Mazda MX-5 Cup Car Technical Service Bulletin # 2026-09-11

2025+ Mazda MX-5 Cup Car Heater Core Box – Blend Door Fix

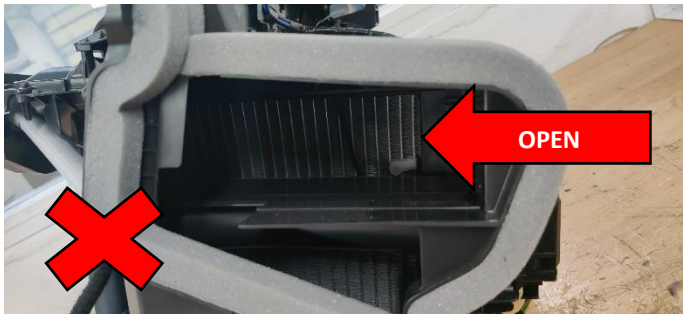
1. Remove the passenger side lower dash panel.
2. Remove the Bosch ECU and ECU bracket to gain full access to the heater core box.
3. Locate the heater core box and remove the two Phillips head screws holding the blend door actuator motor in place.

4. Using a paint pen, mark the gear on the blend door output shaft in its current position. Make sure door is OPEN

5. Rotate blend door drive gear clockwise until the blend door is fully closed and gear has stopped turning.

6. Reinstall the actuator and the two Phillips head screws. The blend door will now remain closed.
